CONTRACT NO. 1797

OHIO RIVER TUNNEL

ADDENDUM No. 5

All bidders bidding **Contract No. 1797** shall read and take note of this **Addendum No. 5**. The Contract Documents for **Contract No. 1797 – Ohio River Tunnel** are hereby revised and/or clarified as stated below.

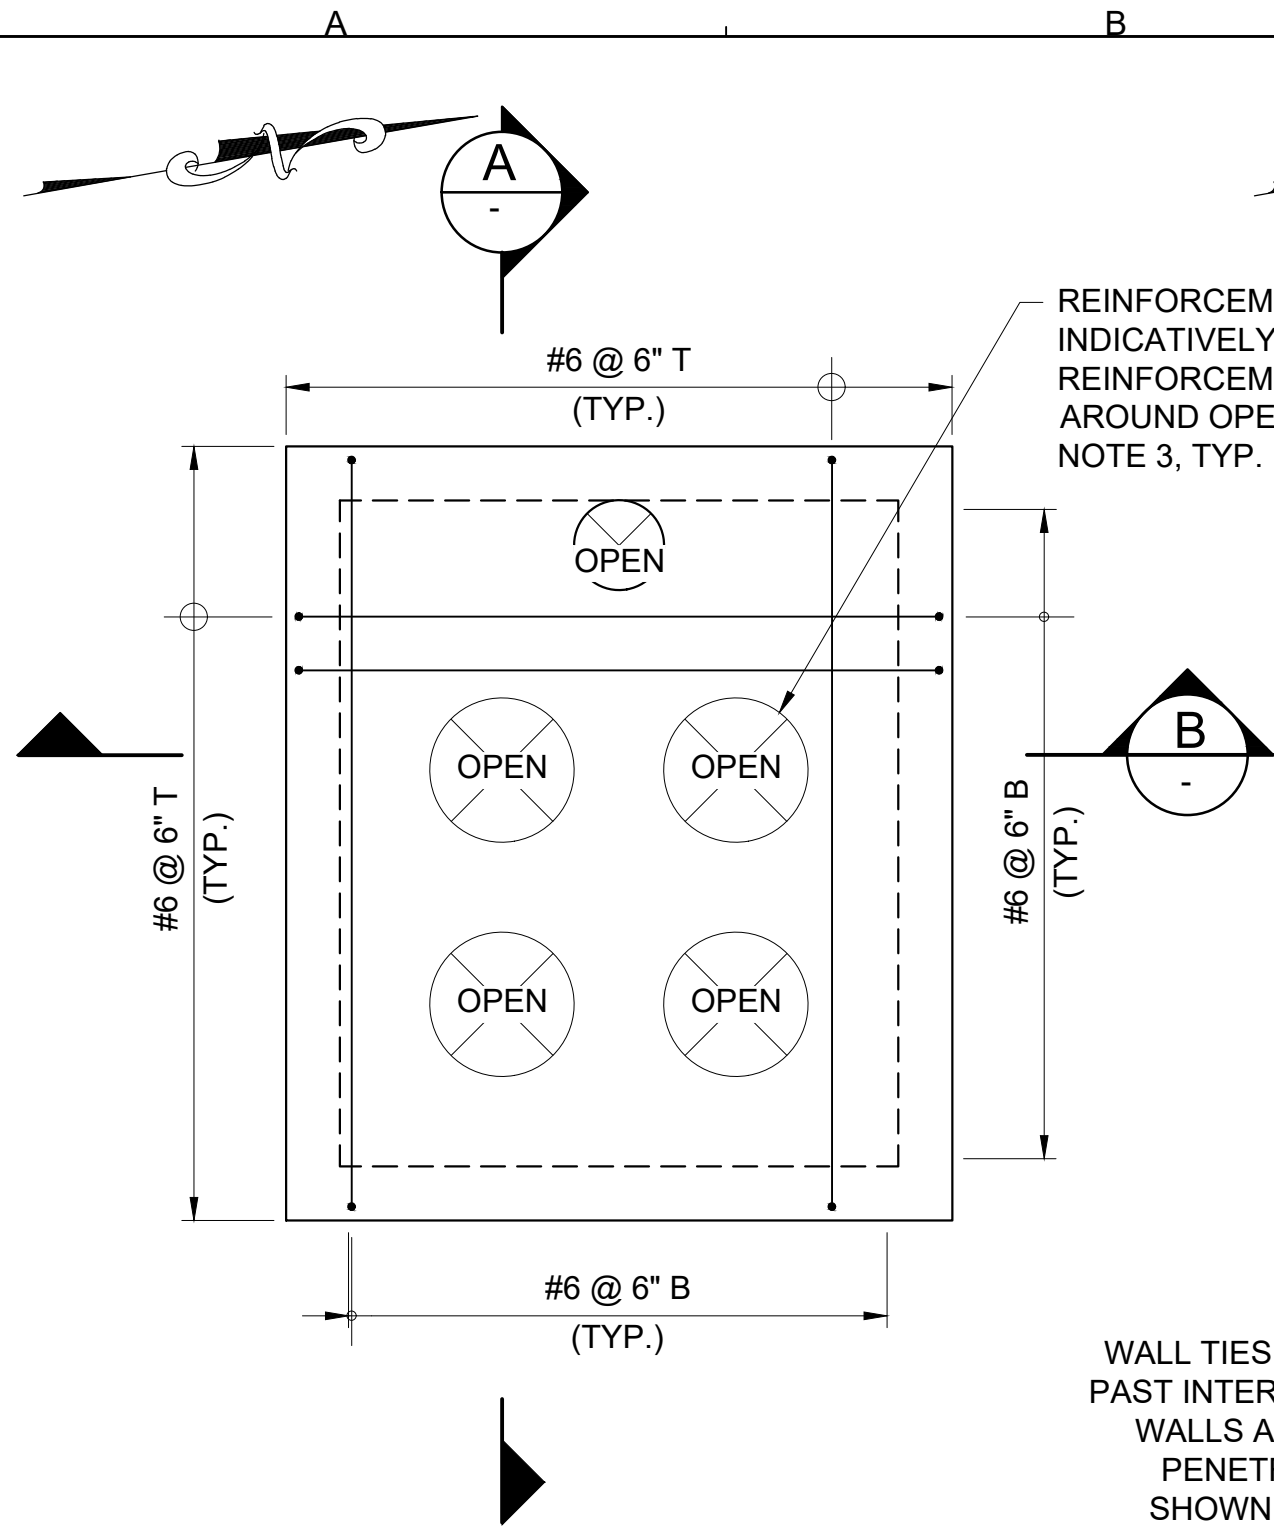
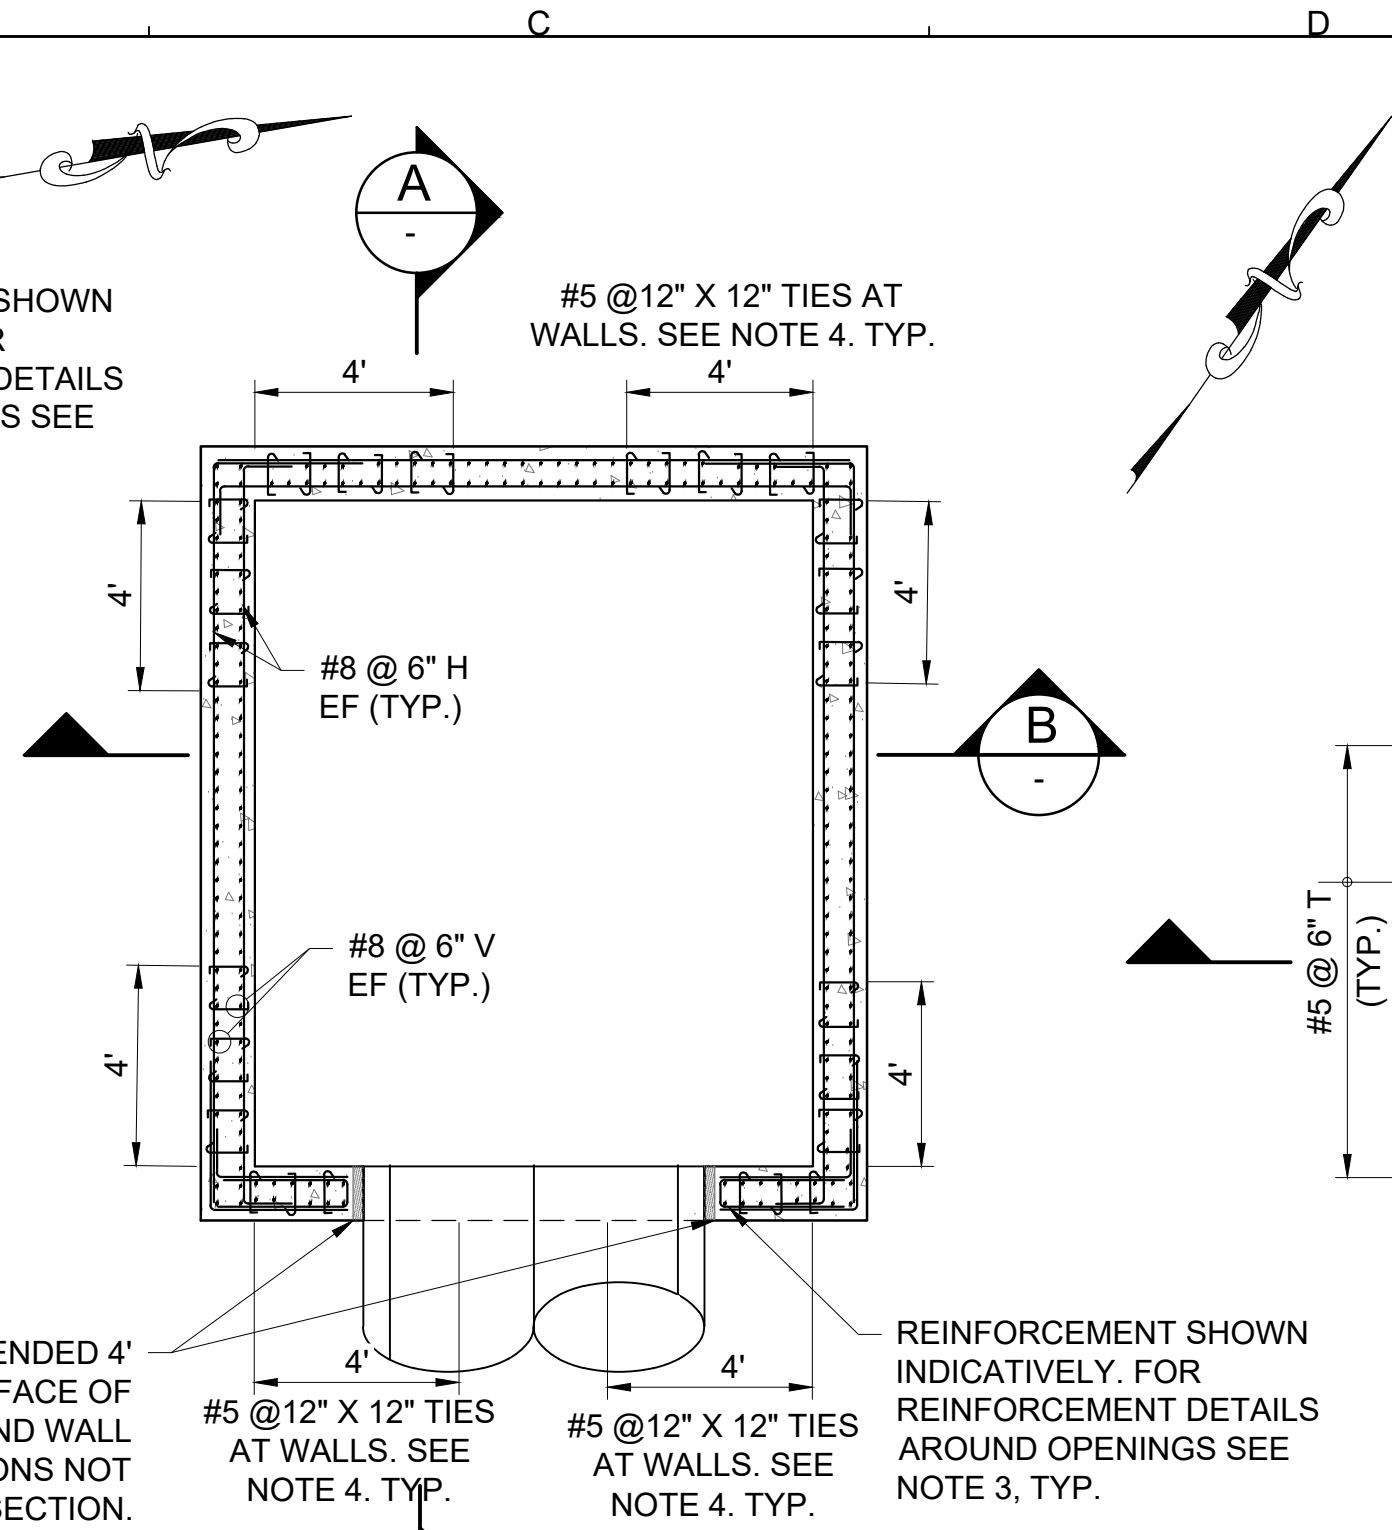
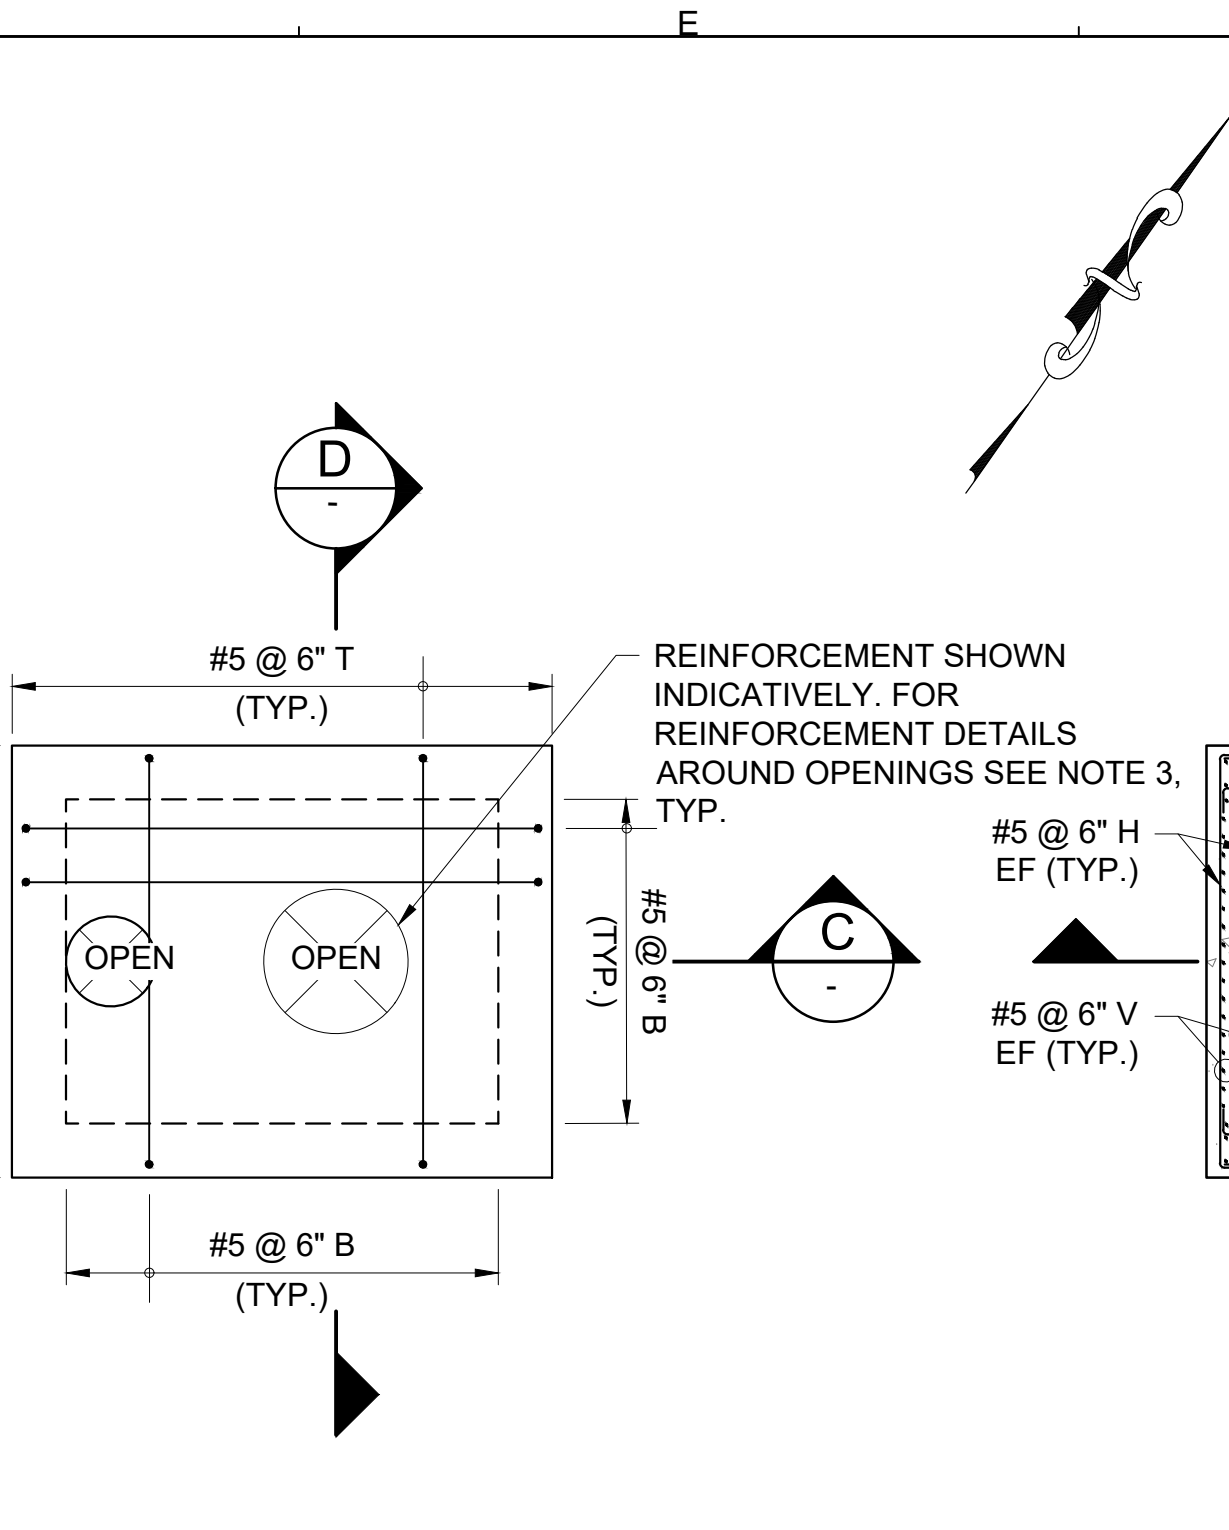
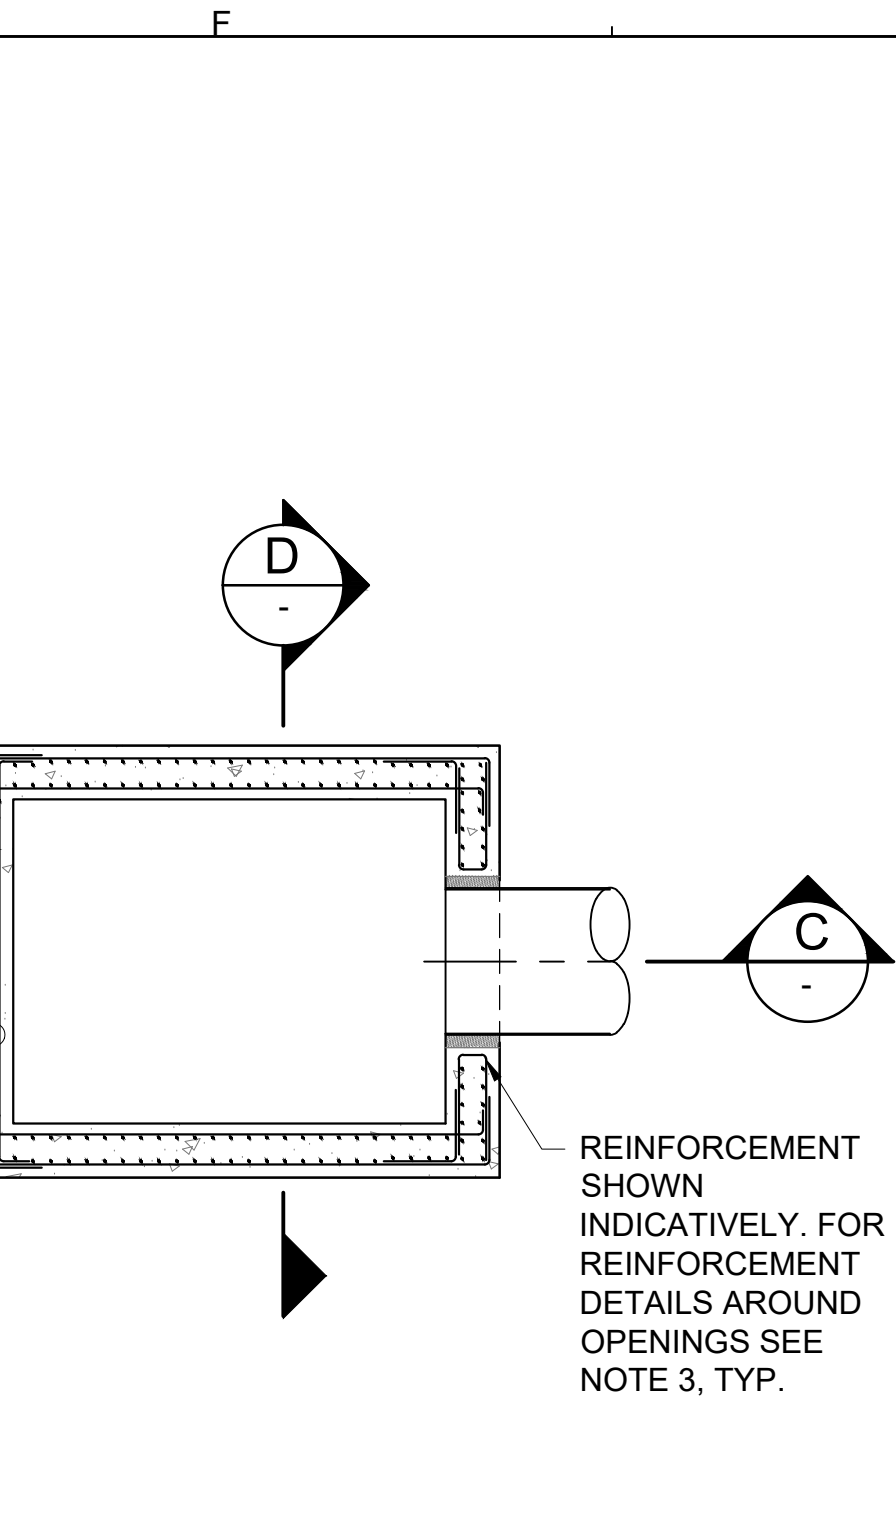
- A2 **This is a dedicated full-time position.**
- Q3 *Ventilation Diffuser SOE - For all sites that contain ventilation diffusers, a support of excavation design is to be designed by the contractor, and submitted to the owner for review and approved. The contract drawings reference in the support of excavation notes under note C, "Any excavation for the ventilation vaults deeper than 4 feet shall be supported by a temporary excavation support system without internal bracing or any elements of the SOE system intruding into the excavation footprint."*

- Please remove these internal bracing restrictions to allow the Contractor and their Engineer to determine the best solution for shoring these excavations.*

- A3 **Drawings O27-ST-142, O27-ST-143, O41-ST-226, A48-ST-315, A58-ST-438, A58-ST-440 O14-ST-628, O07-ST-713, O06A-ST-814, and O06A-ST-815 are revised and attached to this Addendum. See CHANGES TO CONTRACT DOCUMENTS section below and Attachment A of this Addendum.**

- a) DELETE O27-ST-142 (Sheet 245 of 770) and ADD Revised O27-ST-142 (Sheet 245 of 770), which is Attachment A to this Addendum.
- b) DELETE O27-ST-143 (Sheet 246 of 770) and ADD Revised O27-ST-143 (Sheet 246 of 770), which is Attachment A to this Addendum.
